Bulletin No.: 1-SB-006-14052009 Release Date: 20-May-2009 Effective Date: 20-May-2009 Supersedes: -Completion Date: 03-July-2009

# **Service Bulletin**

Original Ride Manufacturer:	Affected Production Dates:
Vekoma International BV	1999 and earlier
Vekoma Manufacturing BV	
Ride Name: Suspended Looping Coaster	Affected Serial Nos: see table 1
Model No: 01201	688-1

Abstract of issue:

## 1.1 Suspended Seat (01201-66-0132)

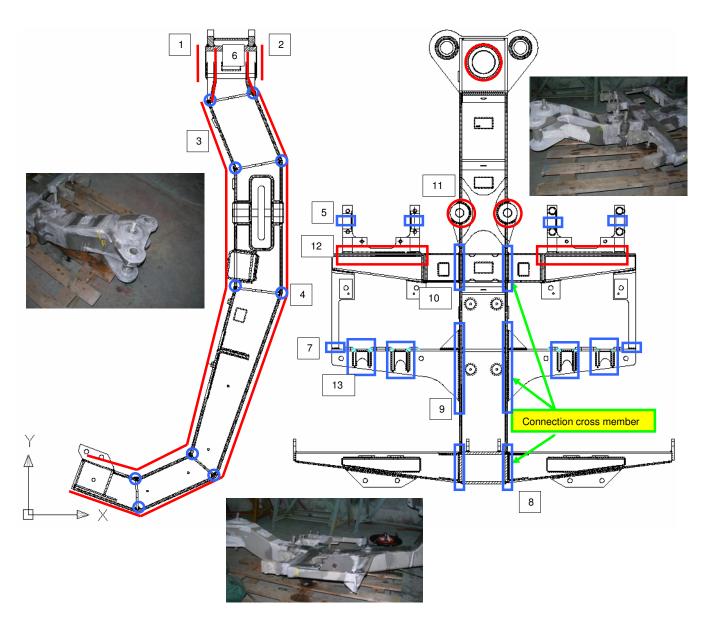
The next paragraphs give a schematic illustration of the weld seams to be tested. The weld seams which are marked in blue symbols need to be tested using MT. The weld seams which are marked in red symbols need to be tested using UT.

In this section a schematic illustration of the suspended seat with the sections to be tested is presented.

No	Description	Test Method
1	Bush hanger pivot point PP (front)	UT (check weld depth with welding dwg)
2	Bush hanger pivot point PP (rear)	UT (check weld depth with welding dwg)
3	V-welds total hanger main beam FP (4x)	UT
4	Horizontal welds in main beam hanger FP	МТ
5	Ratchet blocks	МТ
6	Weld seam op Vertical plates Top part FP	UT
7	Weld seams stiffener (square profile – stiffener plate)	МТ
8	Connection welds lower horizontal bars FP (L+R)	МТ
9	Connection welds middle horizontal bars FP (L+R)	МТ
10	Connection welds top horizontal bars FP (L+R)	МТ
11	Weld seams damper connection bushing FP	UT
12	Weld seam ratchet block PP (L+R)	UT (check weld depth with welding dwg)
13	Weld seam stiffener geometry ratchet connection PP	МТ
